TOWN OF HILTON HEAD ISLAND

William Hilton Parkway Gateway Corridor Advisory Committee

To: Shawn Colin, AICP – Town of Hilton Head Island
From: Nate Nohren, PE, PTOE
Date: April 5, 2024
Subject: Copy of Power Point Presentation for 4/10/2024 Advisory Committee Meeting
RE: William Hilton Parkway Gateway Corridor Independent Review

William Hilton Parkway Gateway Corridor Independent Review Advisory Committee Meeting

Alternative #4 – Elevated Bypass

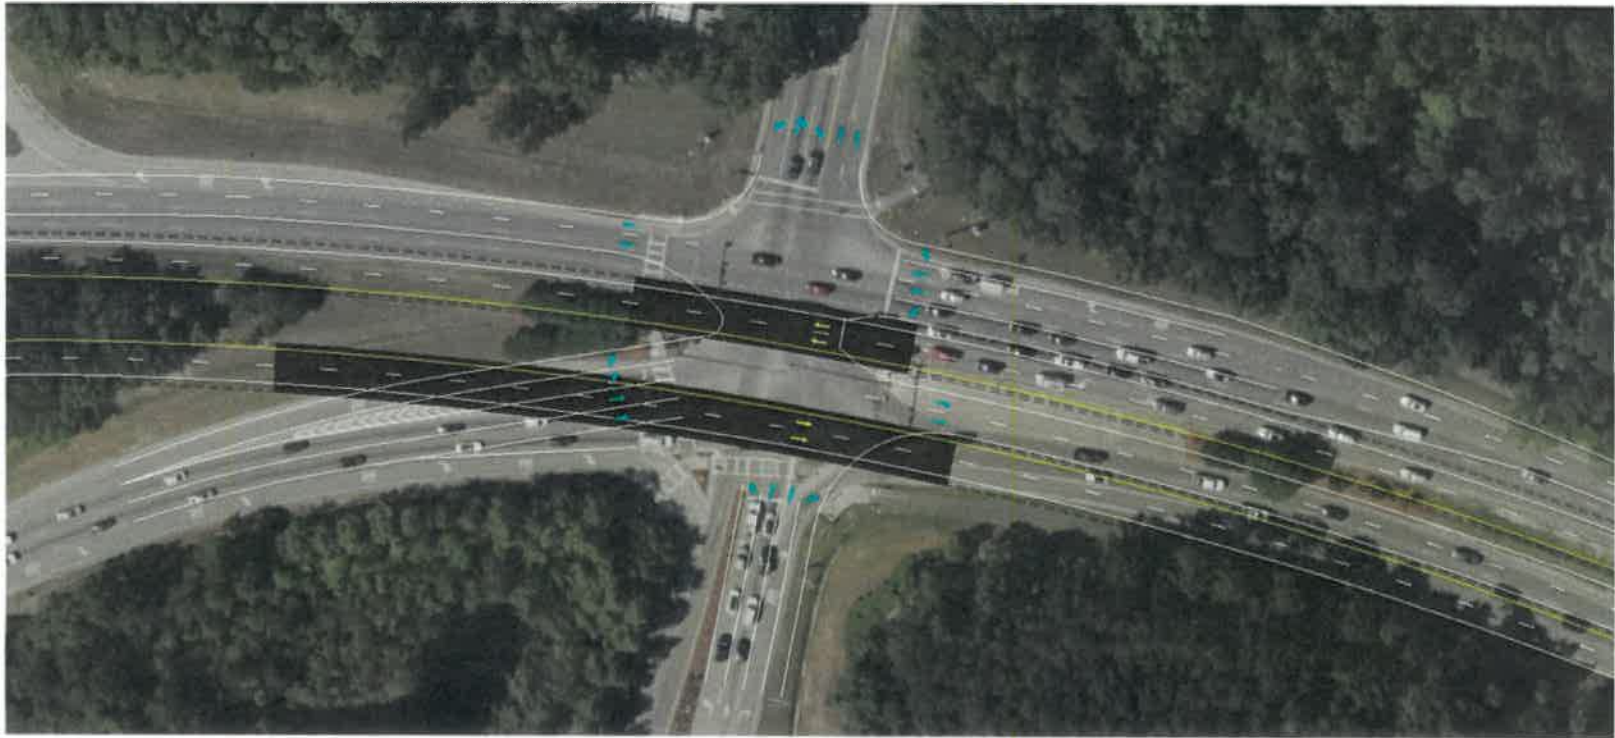
- Pros of Elevated Bypass
 - Improves safety as fewer through vehicles would remain at grade, reducing the conflicts between vehicles and pedestrians
 - Increases the efficiency of the at-grade signalized intersections
 - Significantly reduces the size of at-grade intersections
 - Provides room for growth along the corridor
- Cons of Elevated Bypass
 - Most expensive alternative
 - Results in the largest construction impact
 - Requires grade separation
 - Requires a change in decision making as drivers looking to go through the local intersections of Squire Pope, Old Wildhorse Drive, and Spanish Wells would need to enter the bypass.
 - However, full access would still be provided at-grade

- Summary of forecasted operating conditions:
 - The following at-grade intersections would be able to be reduced in size and would be expected to operate at an overall LOS C or better:
 - Squire Pope
 - Spanish Wells
 - Gumtree
 - Full access could be available at Old Wild Horse
 - Overall, the study intersections are expected to operate acceptably under Alternative 4
 - The signalized intersections throughout the corridor are expected to operate with a LOS C or better overall
 - Side-street and unsignalized approaches throughout the corridor may still experience long delays
- Travel times were performed in Synchro along the Hilton Parkway corridor between Moss Creek and Indigo Run.
 - When compared to the 2045 No Build Scenario, the following changes in travel time were calculated:
